Docket Item #8  
BAR CASE #2006-0128

BAR Meeting  
July 5, 2006

**ISSUE:** Rear addition and alterations

**LOCATION:** 509 Cameron Street

**Figure 2 - Proposed rear**

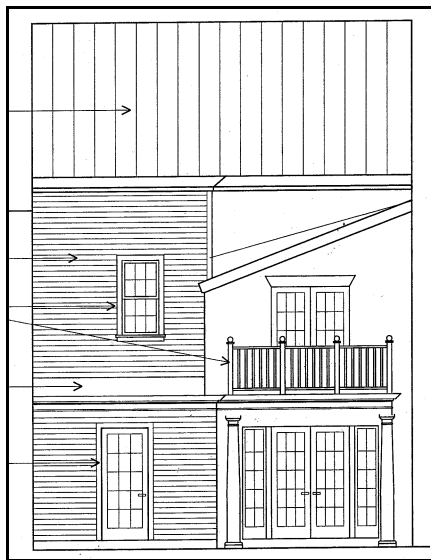
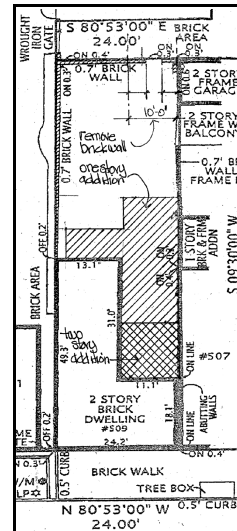
Staff, however, does have concerns about altering the fenestration on the east wall of the second story of the flounder ell. Staff believes that the existing fenestration should be retained to illustrate the historical evolution of the house.

The proposed rear elevation would alter the appearance of the house too drastically, especially the addition of plank siding, the balcony, the porch with Doric columns, and French doors. It is unclear to what extent the side elevation would be transformed (the balcony and Doric porch would alter the historical profile of the house.)

- plan sheets that involve demolition or ground disturbance (including sheeting and shoring and grading) so that on-site contractors are aware of the requirements; and
4. Retention of the existing fenestration on the east wall of the second level of the existing ell.
